Inspection Report Minerals Regulatory Program October 01, 2010

| Mine Name: Fox Canyon | Permit Number: S/049/0080 |
| Operator Name: Beck & Beck Construction Company | Inspection Date: 09/01/2010 |

Extent of operations in September of 2009.

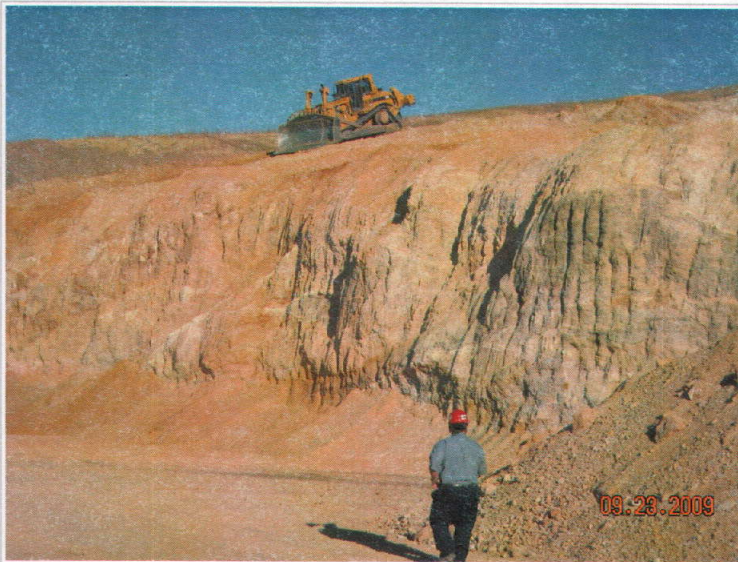
Mostly exempt sand and gravel alluvium material.

Active operations in September of 2009.

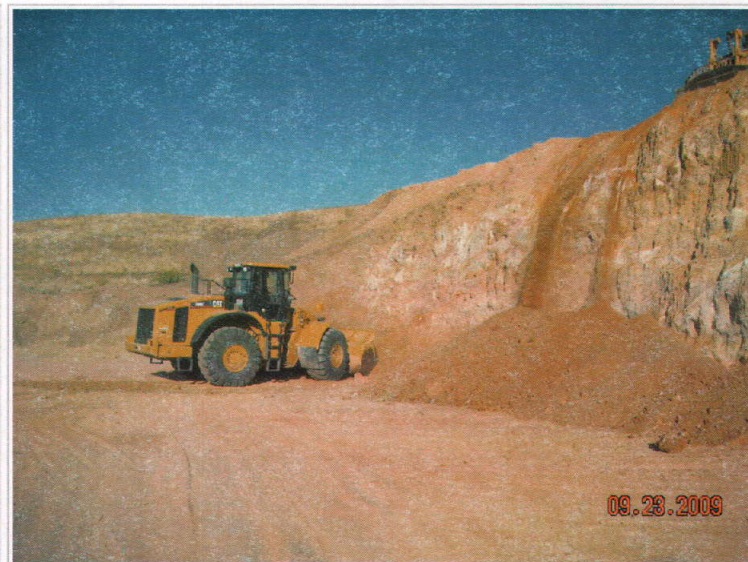
Hard-rock horizon requiring a mining permit.

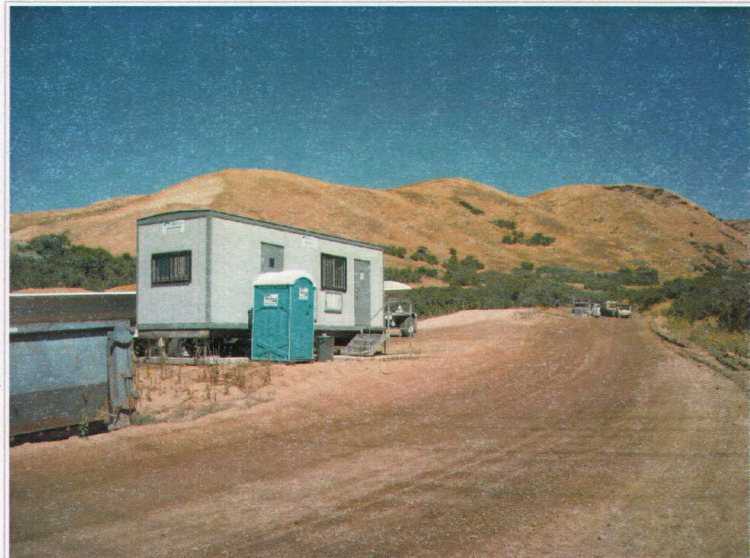
Much larger wall that is cutting into hard-rock.

Area that may pose an erosion stability problem.
